DESIGN MEMORANDUM NO. 1-D

UPDATED MASTER PLAN FOR DEVELOPMENT AND MANAGEMENT OF NIMROD LAKE

DEPARTMENT OF THE ARMY
LITTLE ROCK DISTRICT, CORPS OF ENGINEERS
LITTLE ROCK, ARKANSAS
FEBRUARY 1975

SUBJECT: Supplement No. 5, Updated Master Plan Design Memorandum
No. 1-D, Nimrod Lake

Encl (9 cys)
Plate No. 4 (Land Use Map)

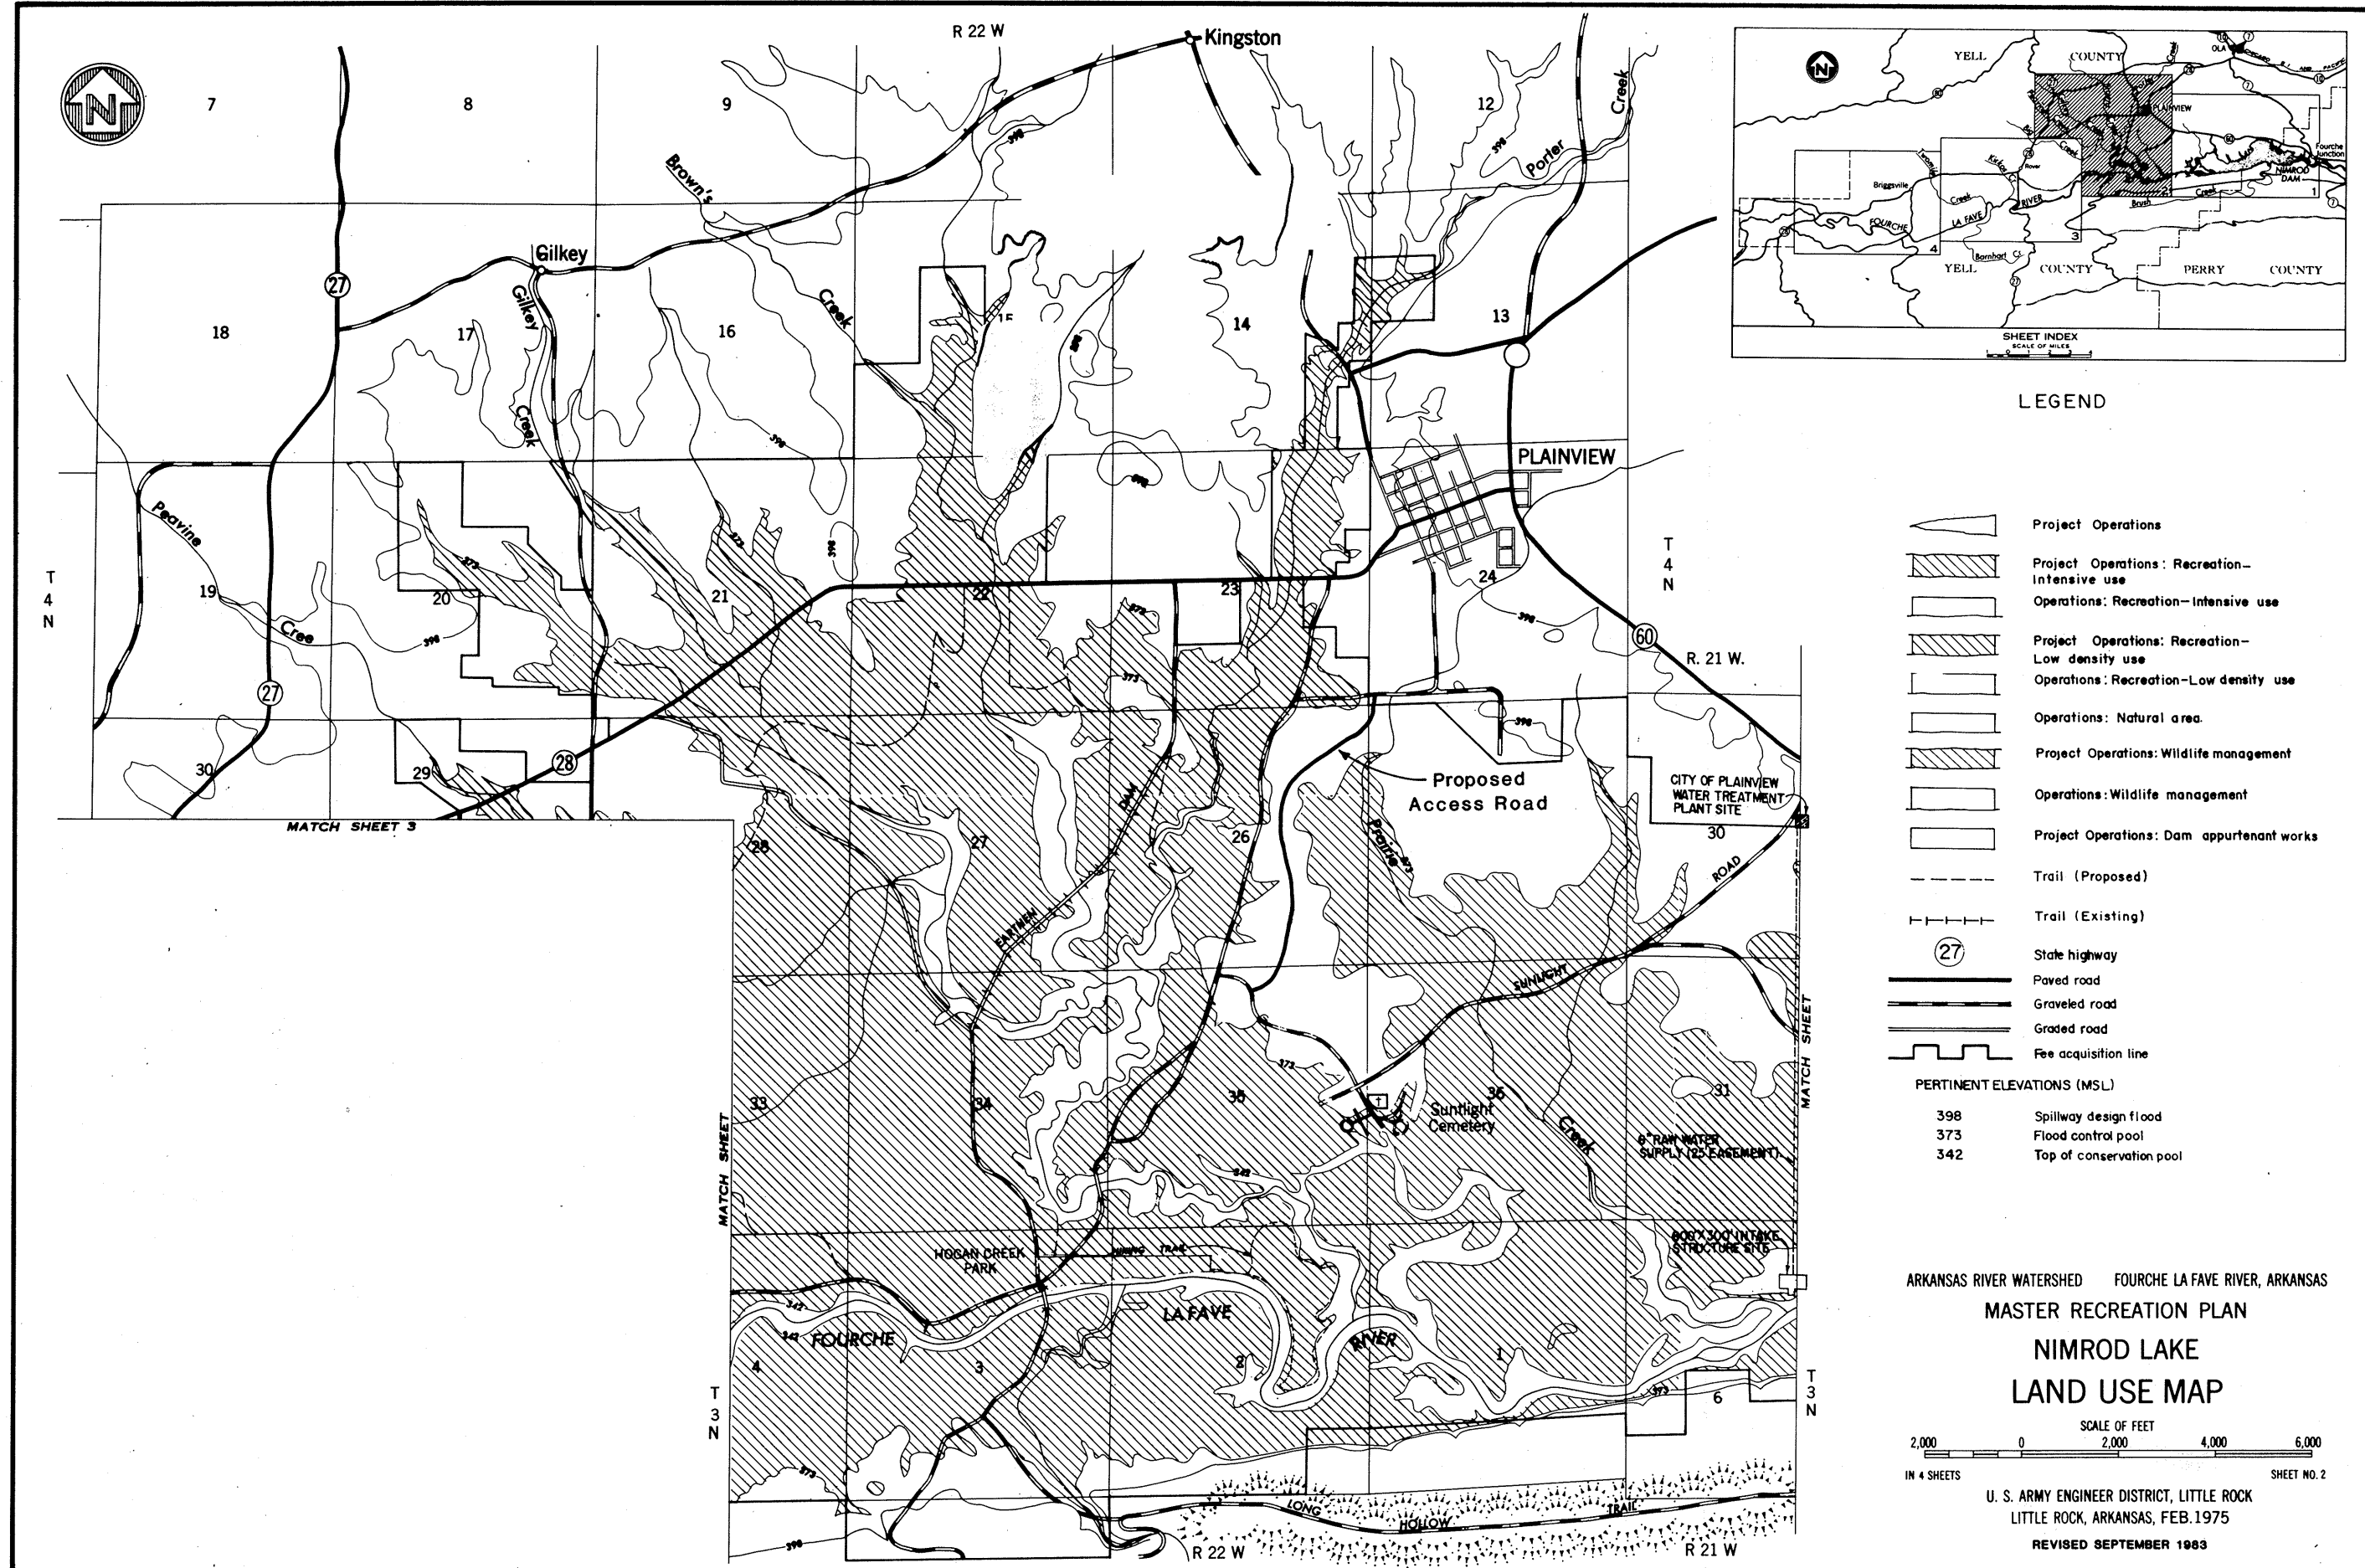
Approved subject to the following comment:

ARKANSAS RIVER WATERSHED FOURCHE LA FAVE RIVER, ARKANSAS  
UPDATED MASTER RECREATION PLAN  
NIMROD LAKE  
CARTER COVE  
PARK

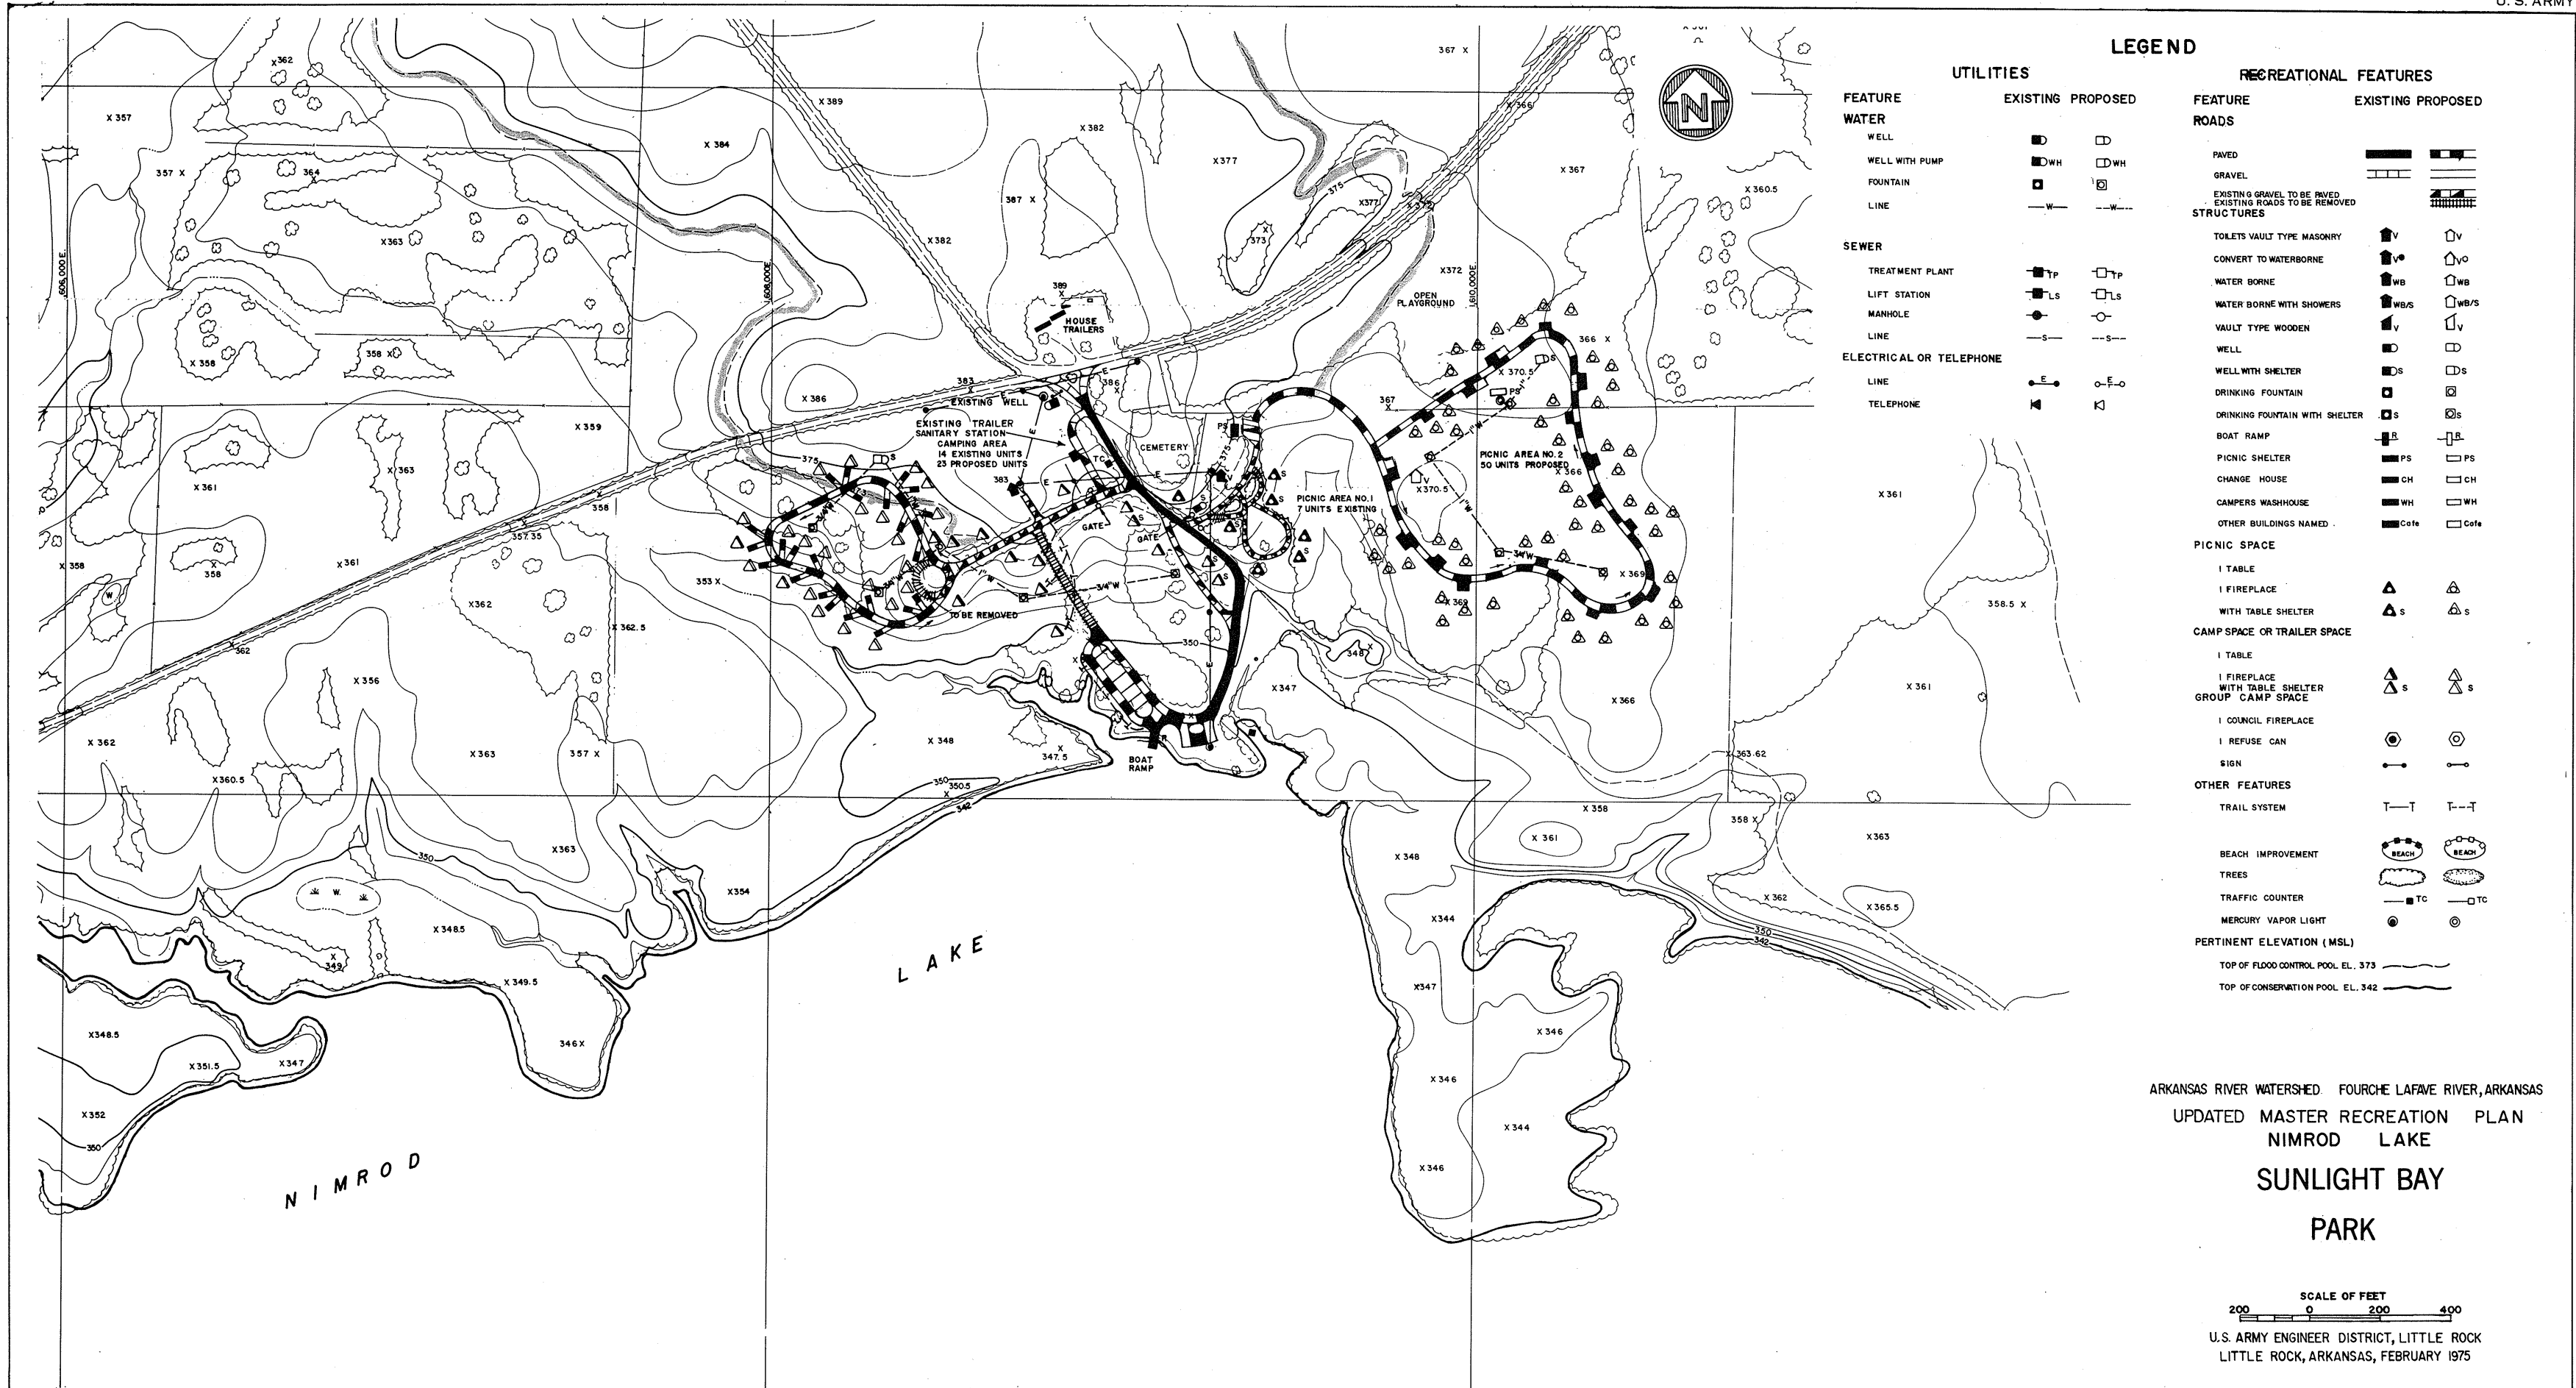
Location of the proposed sewage treatment plant shown on Plate 11 should be reconsidered. The facility could become quite foul smelling and should be located in a more isolated area. Also there is insufficient information presented to properly evaluate the water and wastewater systems.
